Re: Response to Comments
6134 Old Mill Road NE
Bainbridge Island, WA 98110
Project No. 170422

You requested that Aspect Consulting, LLC (Aspect) provide responses to the third-party review comments from the City of Bainbridge Island (City) for the proposed residence accessory dwelling unit (ADU) and garage (Project), located at 6134 Old Mill Road NE in Bainbridge Island, Washington (Site). This memorandum is to be used in conjunction with Aspect's *Geotechnical Engineering Evaluation and Critical Areas Report* dated August 29, 2017. This letter was completed in general accordance with our agreed upon scope of work dated October 16, 2017.

Attachment: Slope Stability Analyses (revised)

Section A-A' Static Conditions

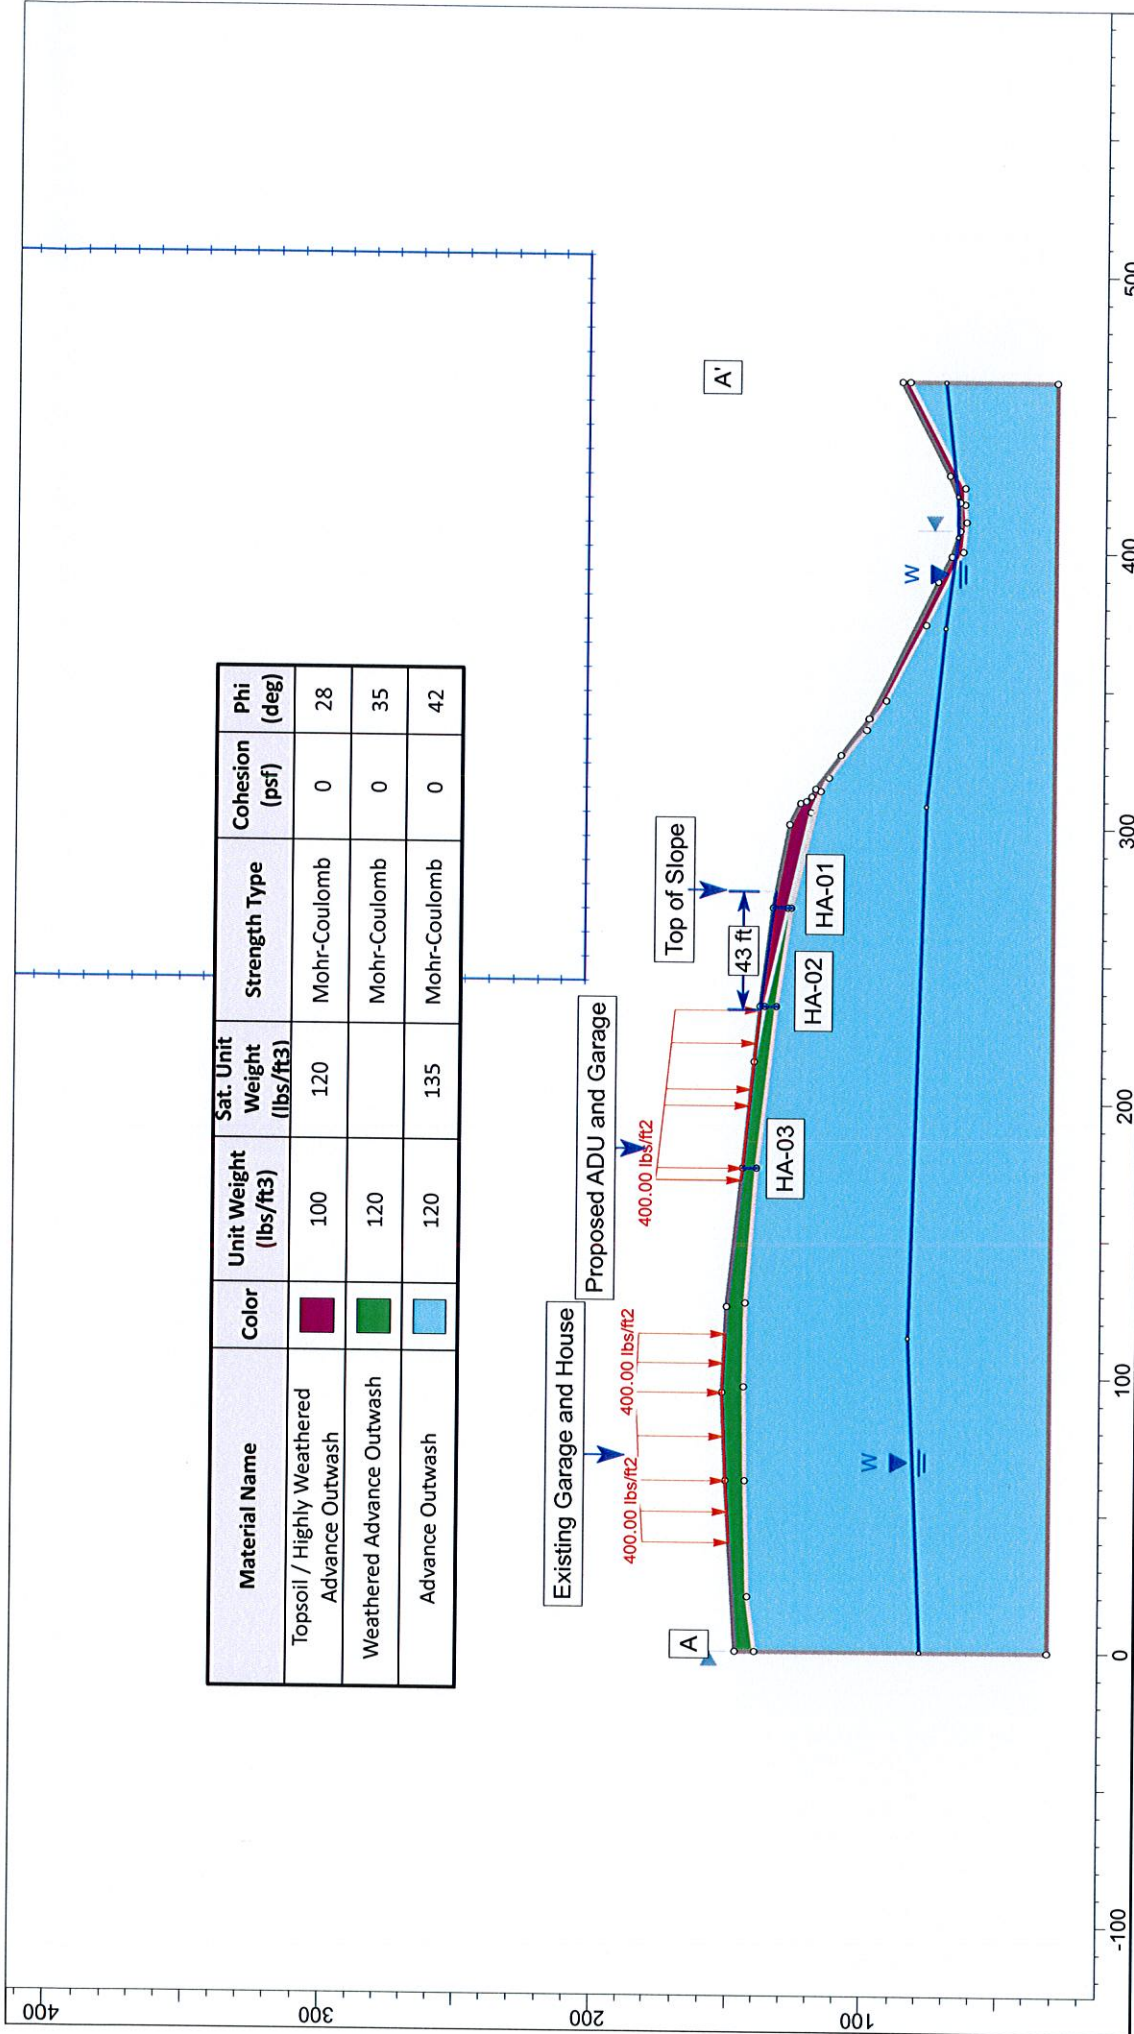
(a) Table 2 on Page 7 of the report states that the static factor of safety is greater than 1.5 and that the seismic factor of safety is greater than 1.1 at a distance of 43 feet from the top of the steep slope. The slope stability results in Appendix B on Figures B-2 and B-3 present the minimum static and seismic factors of safety achieved for a shallow failure surface of 0.902 and 0.506, respectively, which is not consistent with the results presented in Table 2. While we infer that Aspect are trying to show that the lowest factors of safety occur within the colluvium, we recommend that Aspect present the factor of safety for a failure surface that terminates at the edge of the recommended buffer and setback. In addition, Aspect state in the paragraph below Table 2 that a seismic factor of safety greater than 1.0 was achieved, which is also inconsistent with the “greater than 1.1” shown in the table. We also recommend that Aspect provide further discussion and clarification of the stability results.
